**The City of Lake Forest
Zoning Board of Appeals' Meeting Agenda**

Monday, November 23, 2020

1150 E. Westleigh Road Pool Setback Variance

2 N. June Terrace Front and Side Yard Setback Variances

OPTIONAL STUDY

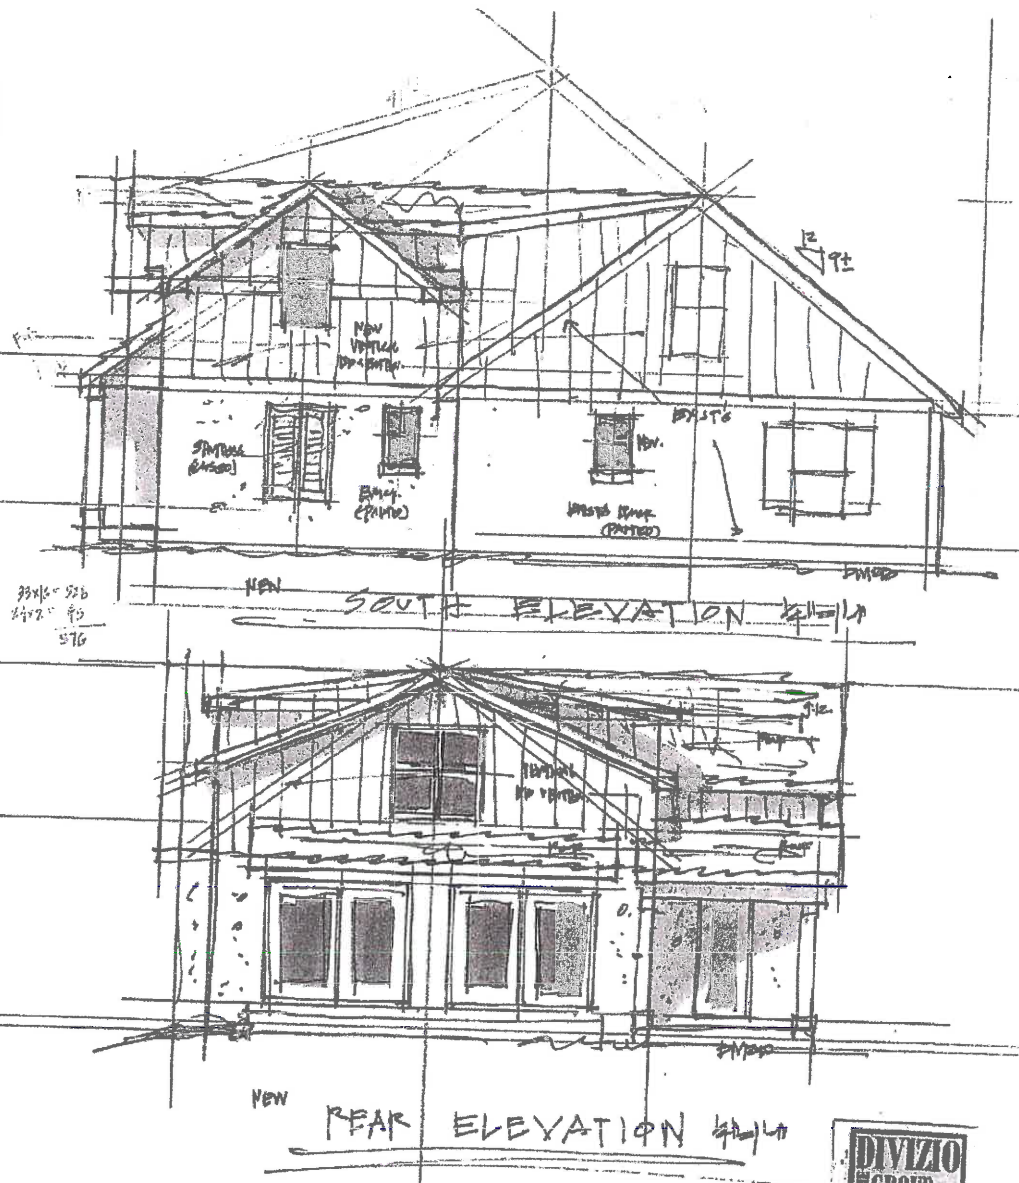
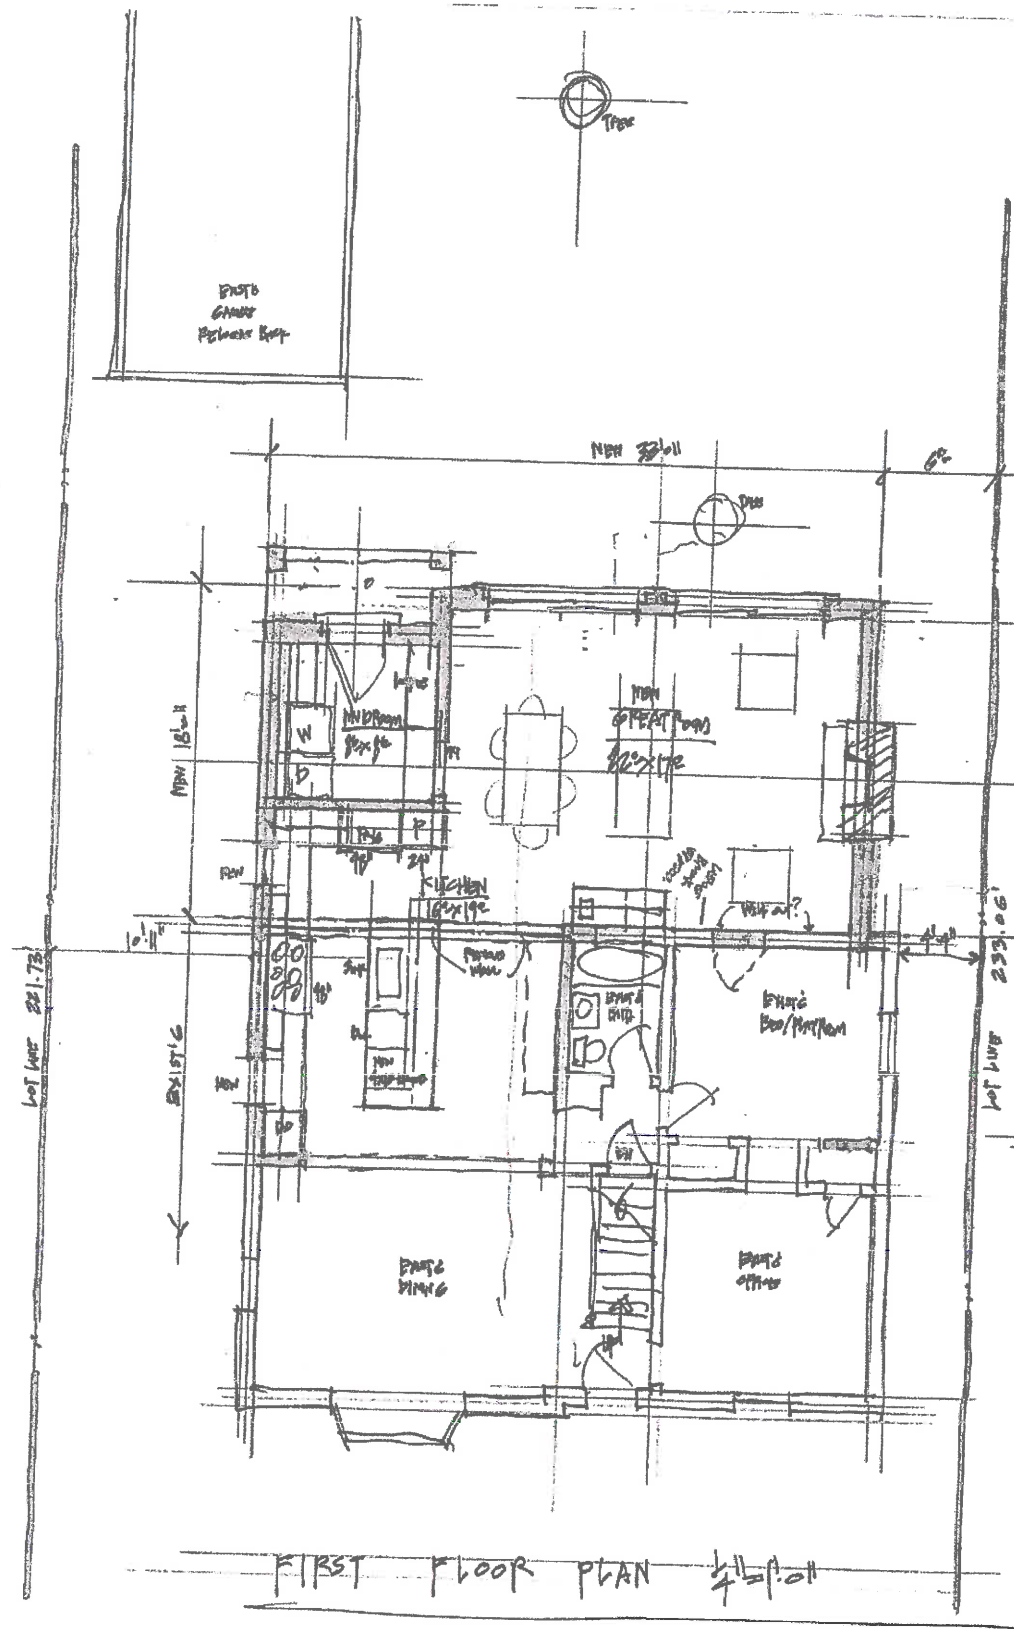
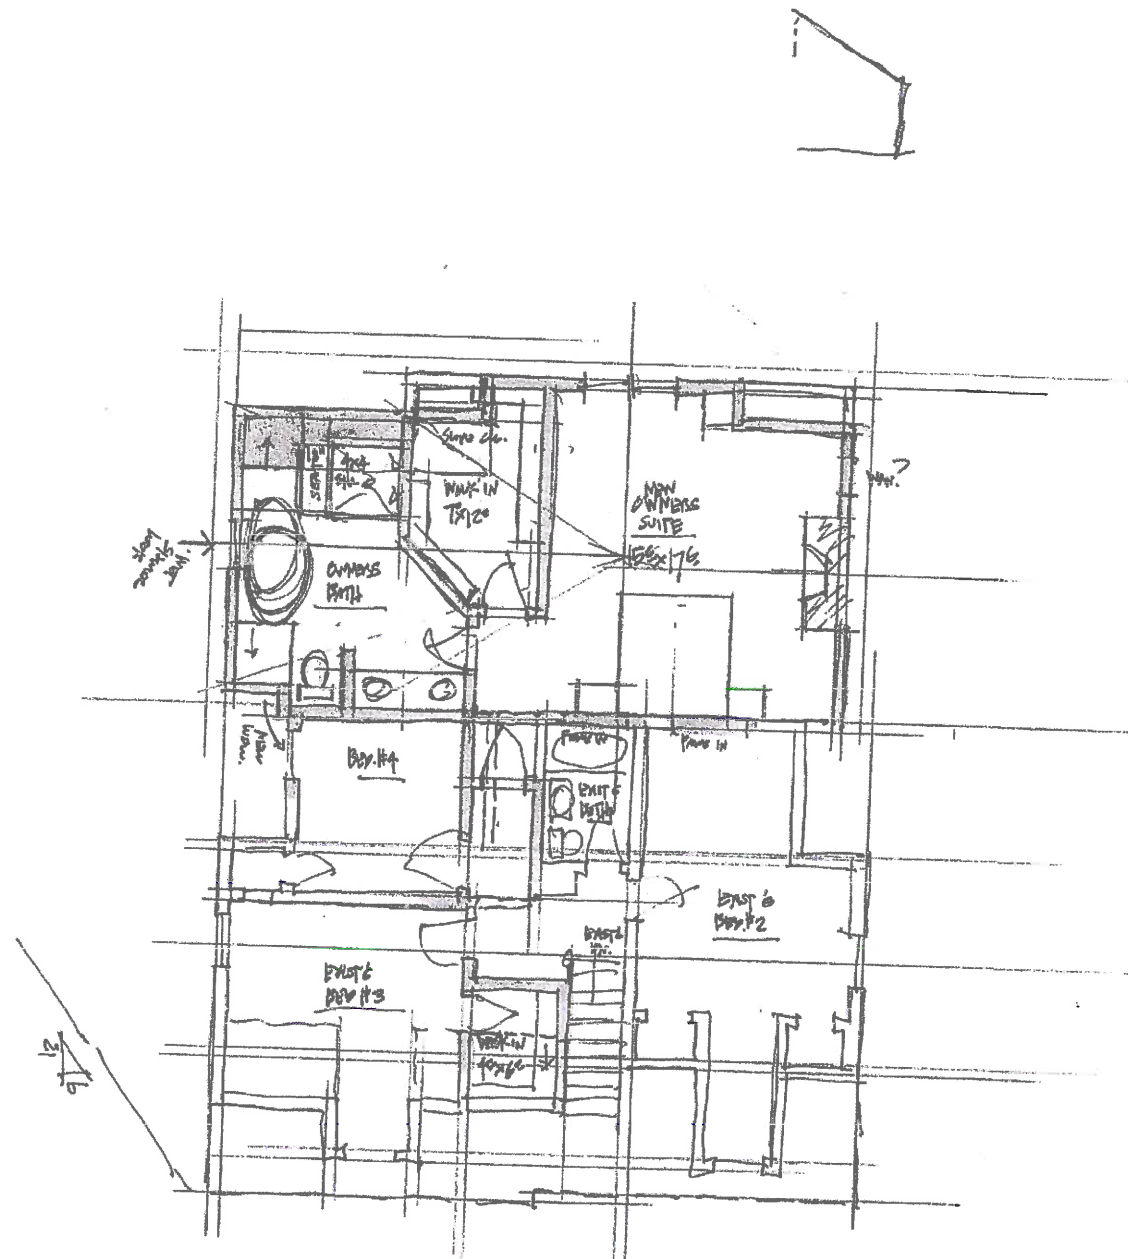
A conceptual plan that demonstrates the opportunity to expand the home in a way that does not encroach into the six foot north side yard setback was submitted by the petitioner and is included in the Board's packet. This concept, and possibly others, merit further study and development by the petitioner to fully explore ways to expand the house without significant construction in the side yard setback.
